From **Highways Development Management Officer**

Application Number 20211019

Location;- 28 Park Road Gravesend Kent DA11 7PR

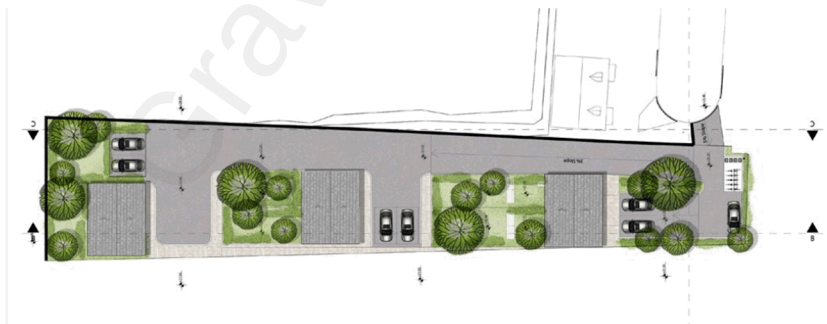
1. There is insufficient space to ensure a standard GBC refuse freighter can turn, it is slightly short of the 12 metres maximum permitted, so any development should be able to safely accommodate a 12m x2.55m (without mirrors extended) with the mirror extended, lorry turning within the site, and negotiate the 90° bend at the site entrance.

2. Car parking provision should be an average of a minimum of 1.5 spaces per dwelling in a suburban location to comply with the Highway Authority published guidance in Kent Design Guide Review: Interim Guidance Note 3 Residential Parking. Plus there would be a need for a single visitor space making a requirement of 10 in total. Only 8 are shown.

3. Generally KCC would look to adopt the access to a development serving more than 5 dwellings but with the lack of footways and margins this seems unlikely in this case.

4. Suitable secure and weather proof cycle parking should be provided and this includes meeting the needs of people that require adaptive cycles be it for business, a mobility or other issue. The applicant is referred to Local Transport Note 1/20 for the standard size of an adaptive cycle
